ARCHITECTURAL REVIEW COMMISSION MEETING AGENDA

Department of Community and Economic Development
Meeting Date: February 27, 2020

2.1 (Project CUP-19-005)

Action on a request by Allied Electric Sign for approval of a revised Certificate of Design Compliance for new signs at 7269 S. Union Park Ave.

Proposed Location

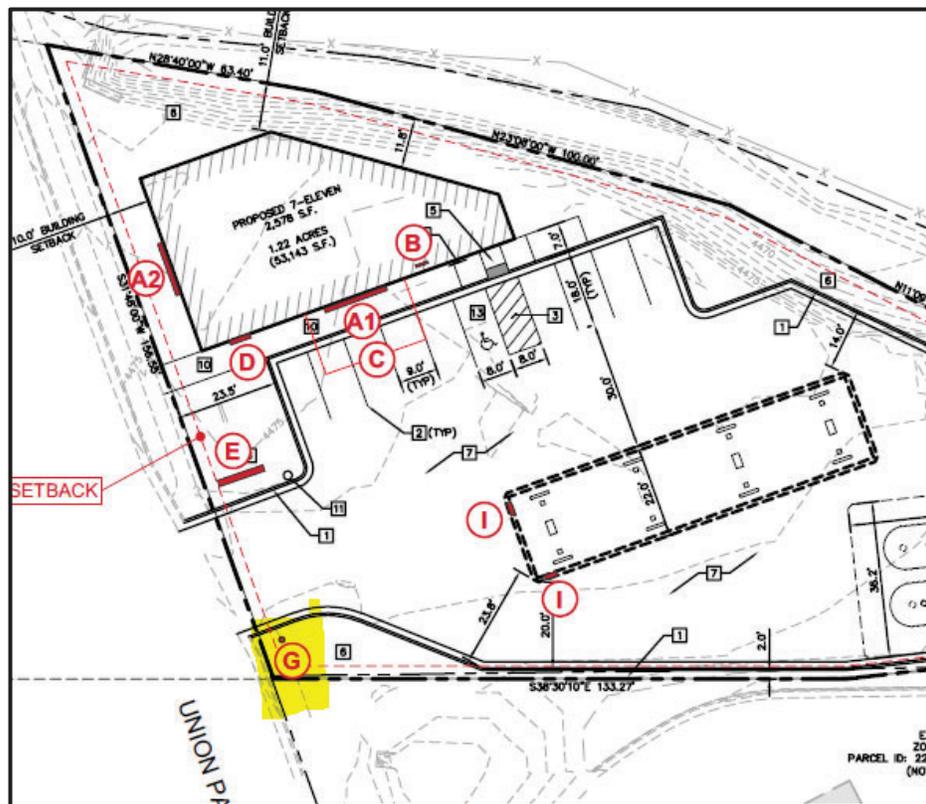
An internally illuminated directional sign with a signable area of 3 sq. ft. is proposed south of the property entrance from Union Park Ave. Directional signs up to 4 sq. ft. in size are allowed per section 19.82.070 of the Sign Ordinance:

Proposed Sign

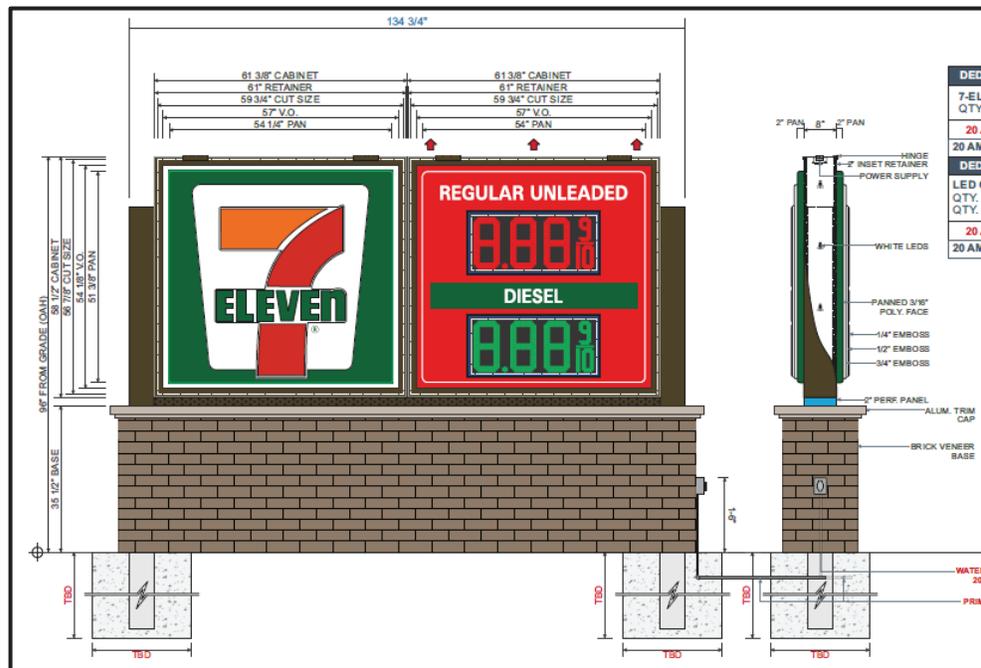
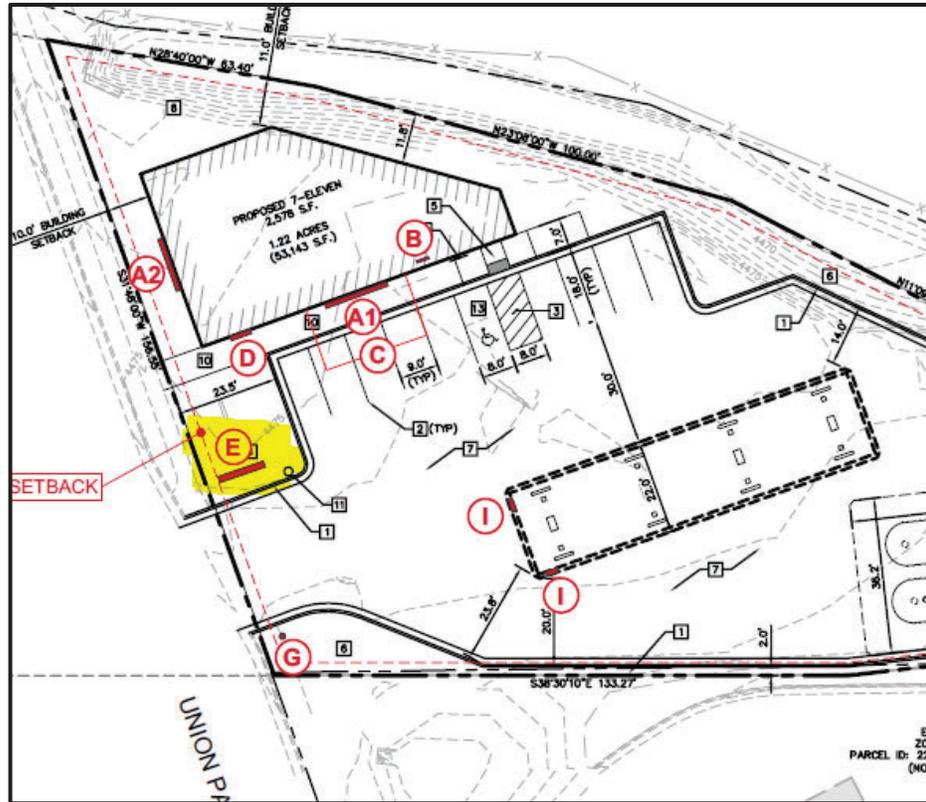
A 90 sq. ft. monument sign is proposed north of the property entrance from Union Park Ave. The sign package specifies that the brick veneer base will match with the building elevation. Monument signs up to 96 sq. ft. in size are allowed per section 19.82.180 of the Sign Ordinance.

There is a median on Union Park Ave. that prevents exiting cars from turning left, so the monument sign placement will not block any clear-view areas.

North Elevation (Retail and Garage section along walkway – no lighting or landscaping shown)

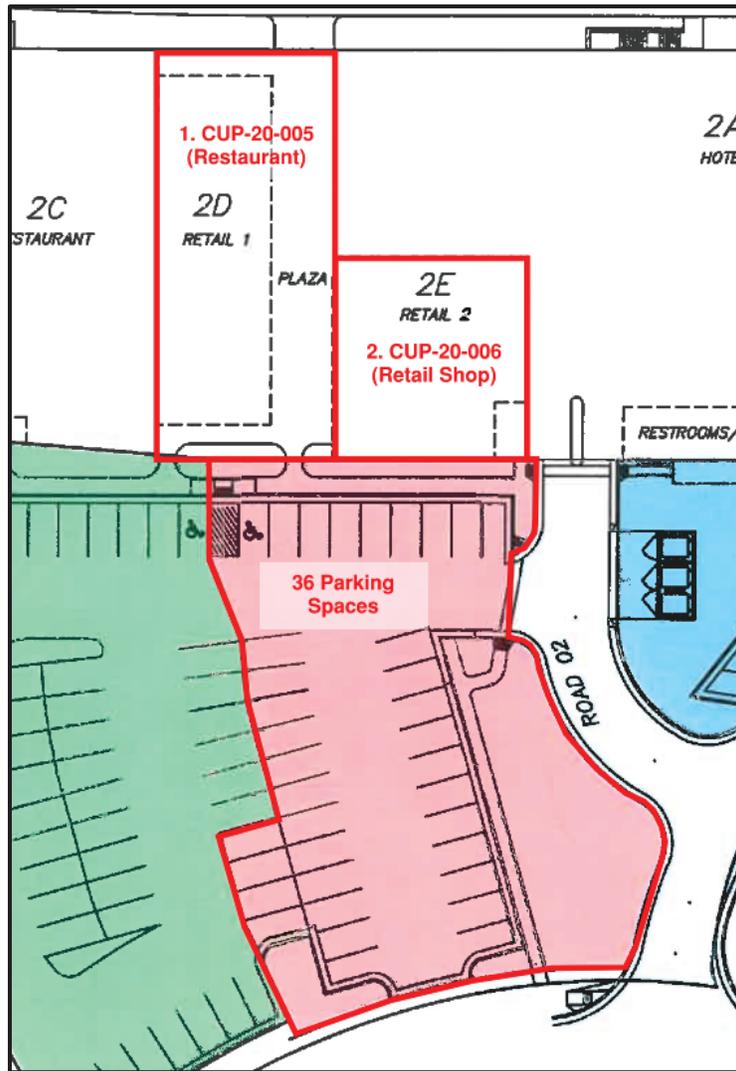
Staff Analysis: The site plan does not specify any design elements along the walkway to encourage pedestrian use. The ARC should consider recommending art, seating, shade trees, or other appropriate design elements in the walkway between the restaurant and hotel. Lighting should conform to the City’s Outdoor Lighting standards, which includes a requirement for pedestrian walkways to “be lighted with bollards or light fixtures” (19.77.050.E).

South Elevation (Restaurant – along plaza/walkway)

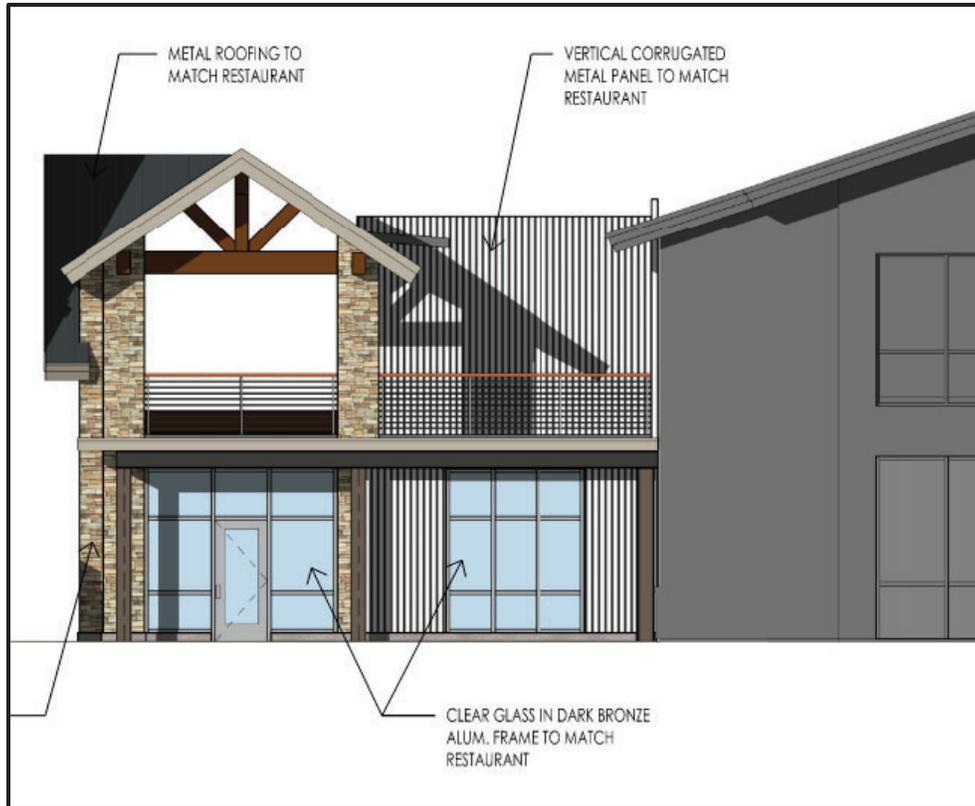
Staff Analysis: The ARC should review the plans and make recommendations to ensure that the entrances are easily identifiable and the signs are compatible with the primary building and the adjacent businesses.

Figure 4.1: Illustrative concept for Gravel Pit segment of the Wasatch Boulevard corridor.

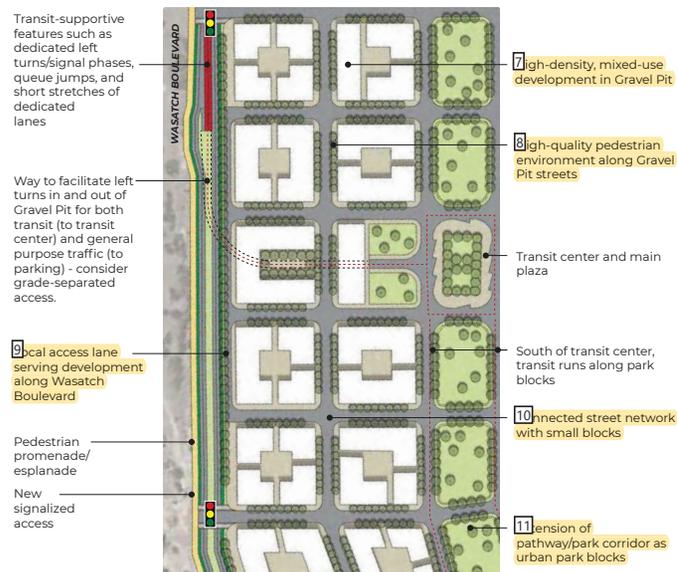
Number: 1	Author: mtaylor	Subject: Highlight	Date: 2/11/2020 9:38:25 AM
Walkable is key here. The current design is pad-oriented with parking disconnecting the various buildings in the site. We recognize that the buildings may not be able to move, but we can address the public realm that connects them and makes this a walkable place. Urban design can overcome a lot of this, including, but not limited to: - alternative placement of the restaurant pad, - finishing a grid-street network as recommended by the plan, - increasing plaza and landscaping space between buildings to increase walkability, and public spaces for sitting, eating, lounging and resting from mountain activities. - Ensuring that building frontage embrace principles of walkability from urban design experts (Duany/DPZ, Speck, Mahron, Jonathan Barnett, Jan Ghel, Smart Growth Network, Congress for the New Urbanism, - Ensuring buildings have a visual interest change no more than every 50 feet (store-frontage change, patios, seating, entryways, (like a traditional urban environment) keep pedestrian interest and increases the desire to walk much longer distances.

Number: 2	Author: mtaylor	Subject: Highlight	Date: 2/11/2020 9:41:49 AM
See above comments on walkability. However, it should be noted that the WBMP considers SR 190 the WB corridor in this instance. The current plans do not include the street frontage improvements on SR 190 as proposed by this plan. This is essential to the entire transformation of the corridor. Pedestrian routes from the proposed internal WB should be extend through the site as part of street grid and also extend beyond parking to SR 190 for maximum pedestrian connectivity as recommended.			
Number: 3	Author: mtaylor	Subject: Highlight	Date: 2/11/2020 9:56:48 AM
Livability is highly subjective, but considering some of the ARC comments, it is essential that the internal WB is designed as a livable street. This is key for the success of the uses along it, both residential and commercial. Fast, loud, busy road will undermine the livability. SR-190 should be the fast through corridor. Every road in the project should be designed for 25 MPH or less. Current design width and travel lane width promotes a 40 MPH+ design speed (regardless of proposed posted speed limits). We need to work very carefully with public works and a qualified traffic engineer to reduce the design speed to 25 MPH or less. This will include lanes 11 feet in width or less, traffic calming, pedestrian priority, increased friction (street parking, bulb-outs, ped-priority areas, etc), four-way stops, possibly no middle turn lane, etc.

Figure 4.3: Illustrative street cross section concept for Wasatch Boulevard in the Gravel Pit area.

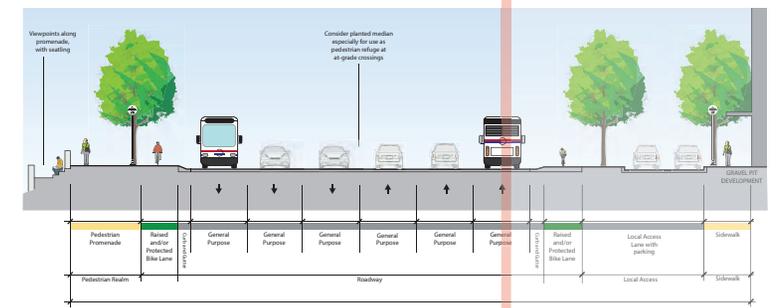
Number: 1	Author: mtaylor	Subject: Highlight	Date: 2/11/2020 10:23:06 AM
These goals in the plan seem largely unaddressed.			
Number: 2	Author: mtaylor	Subject: Rectangle	Date: 2/11/2020 10:24:10 AM

Figure 4.4: Illustrative concept for a pathway network for the Wasatch Boulevard corridor.

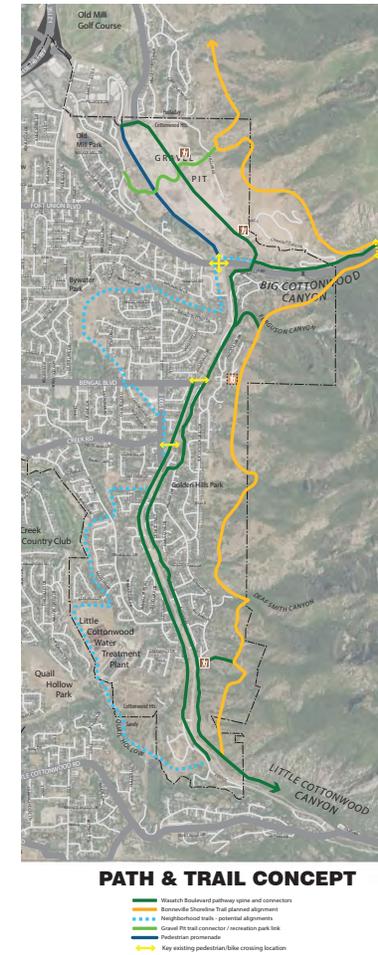
Number: 2 Author: mtaylor Subject: Highlight Date: 2/11/2020 10:25:08 AM
The plan does a fantastic job in achieving this goal.
